## REMARKS

### Amendments to the Drawings

FIG. 4

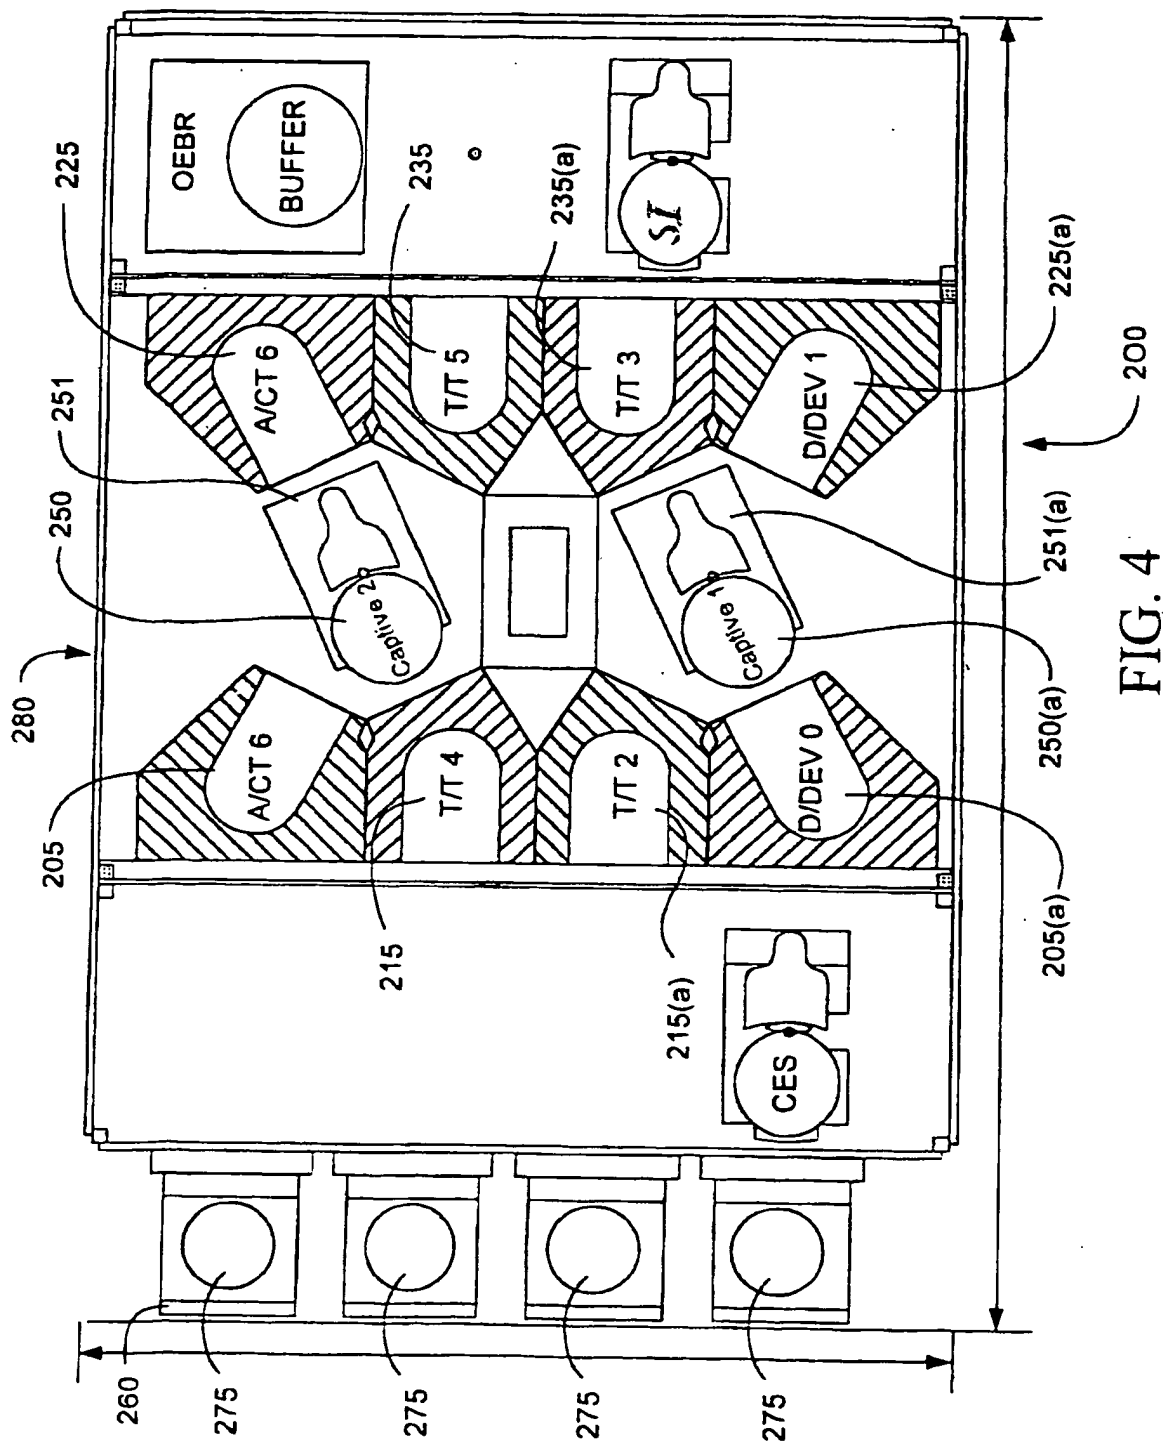
The Examiner objected to the drawings under 37 CFR 1.84(p)(5) as failing to include numerals 280a and 260 on pages 15 and 16 of the specification. The Examiner also stated that it appears I/F in Figure 4 should be changed to SI or I/F given basis in the specification.

Applicant is submitting formal drawings herewith, including a corrected Figure 4 with the appropriate correction made. Figure 4 now includes reference numerals 280a and 260 and I/F has been changed to SI.

Applicant has submitted a replacement sheet of drawings, including a corrected Figure 4.
